BURGER KING - STORE #3099 REMODEL

BLOOMINGTON, MN

PL202300039 PL2023-39

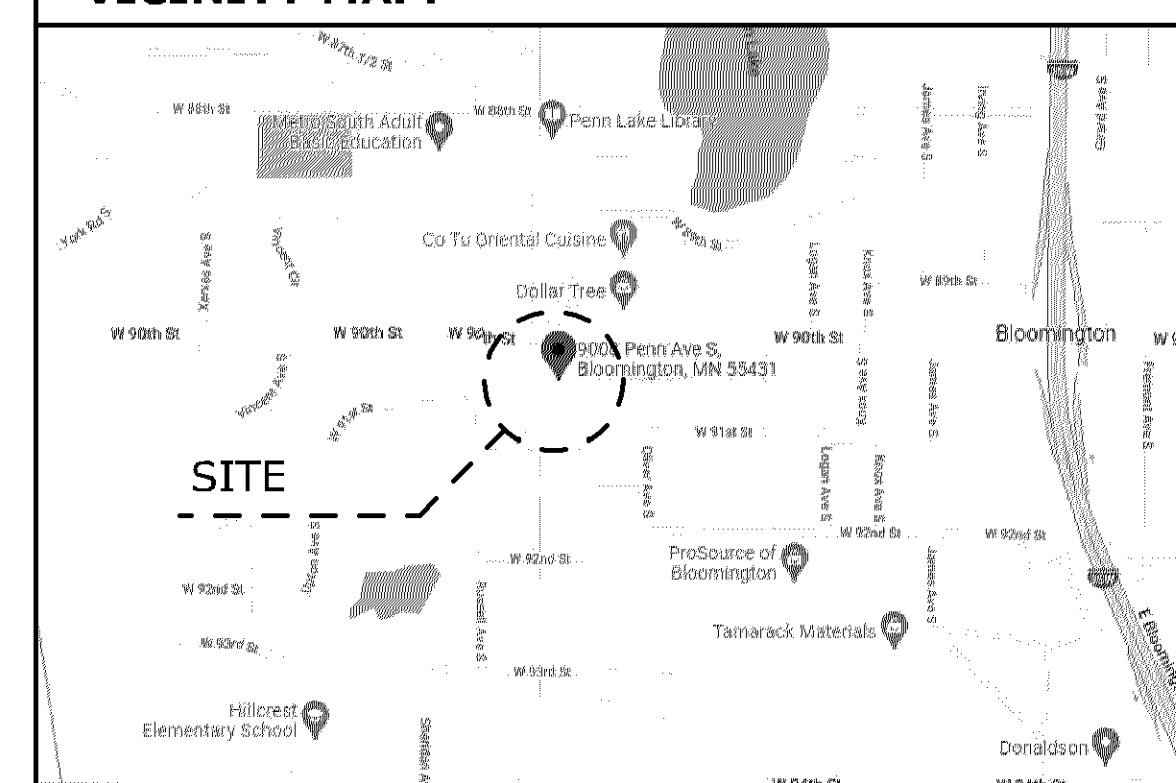
Must meet 2020 MN State Building Code

Building plans must be signed by a MN licensed architect.

SAC review by MET council will be required.

Must meet 2020 MN Accessibility Code.

Provide a detailed code analysis with the plans.

DEMOLITION ELEVATIONS

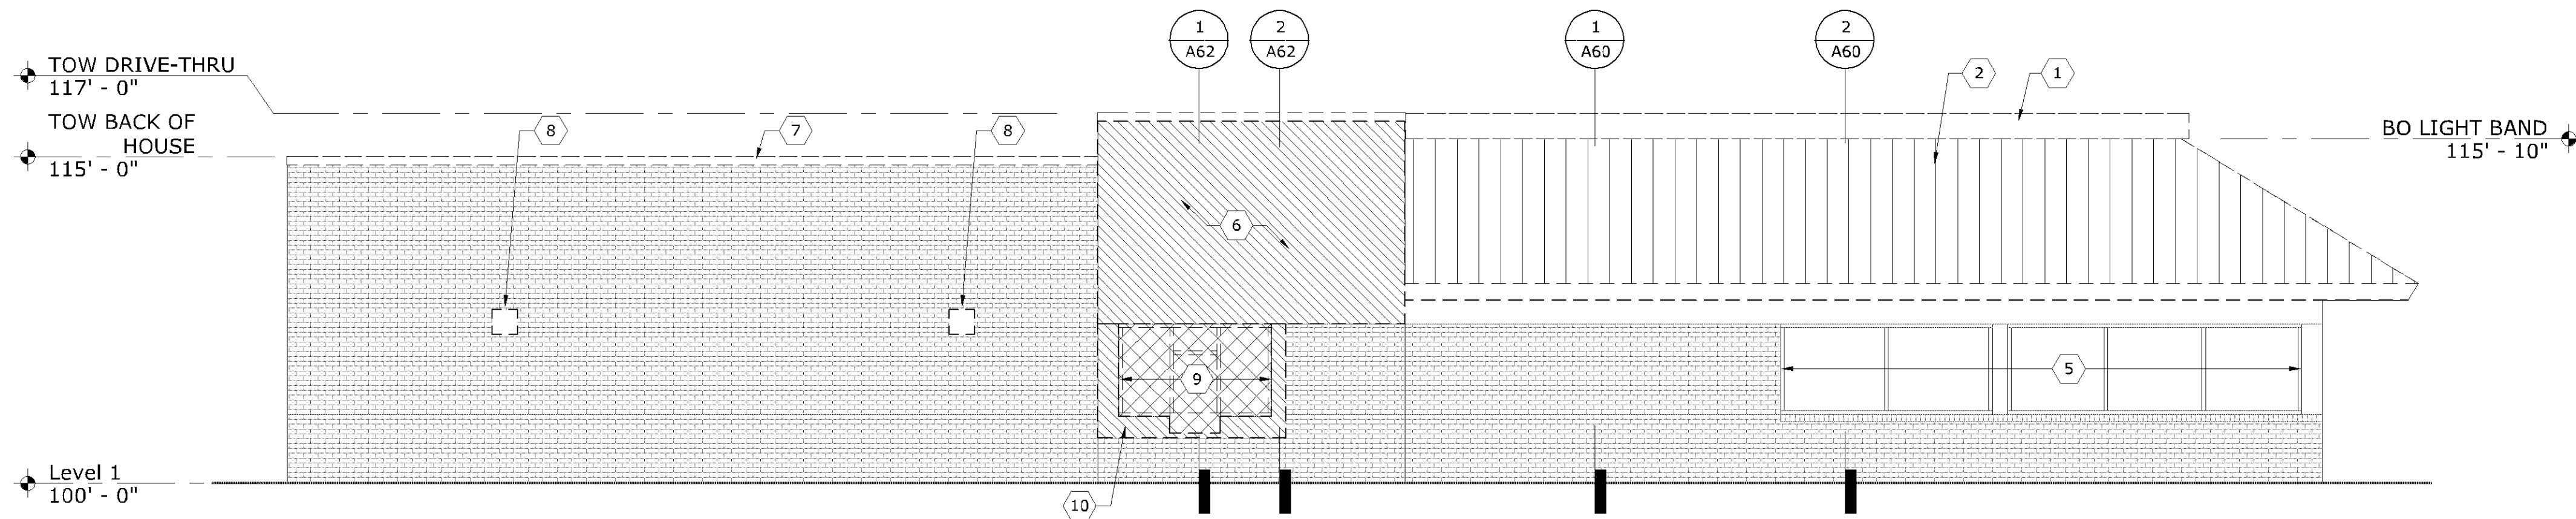
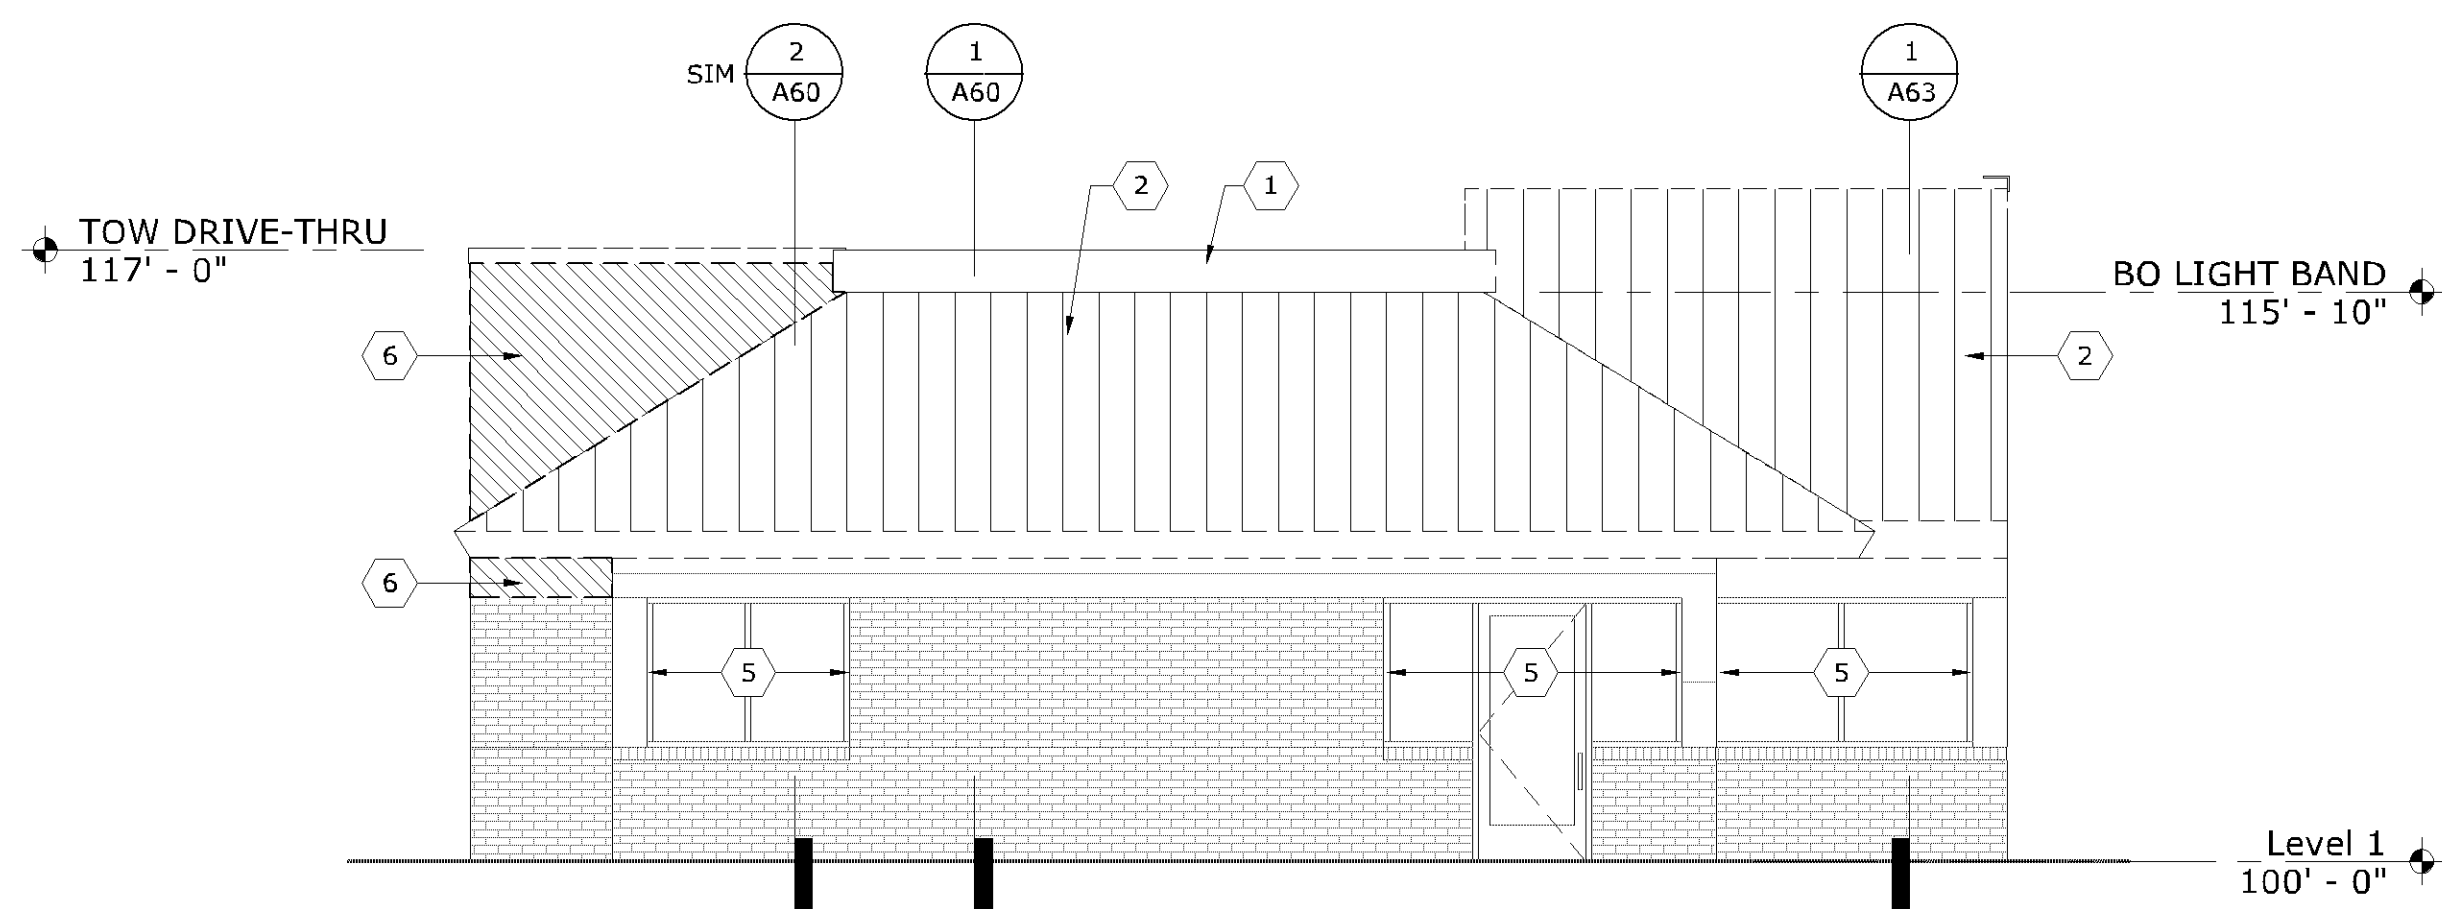
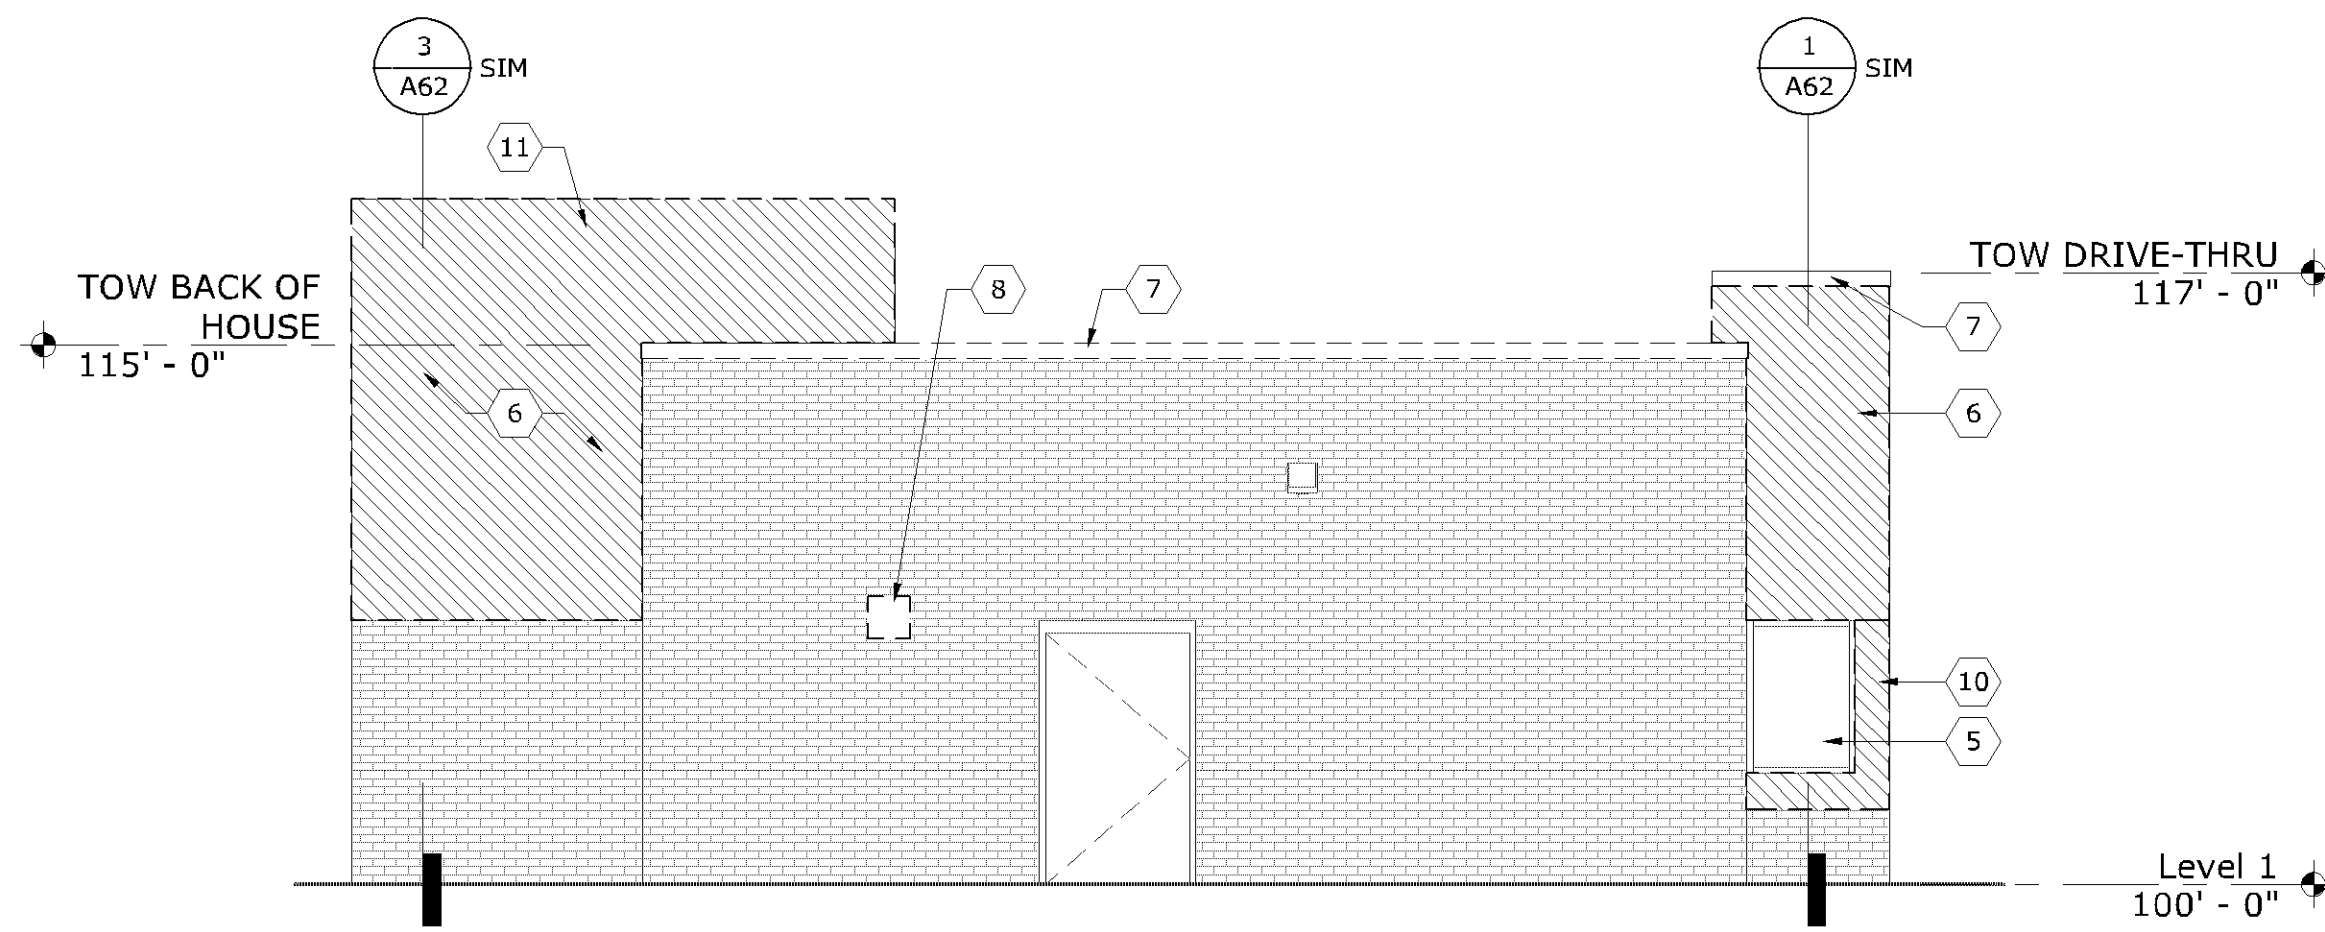
Ensure FDC is clear of obstructions including landscape material and bike rack.

Building/property shall be adequately signed for emergency response.
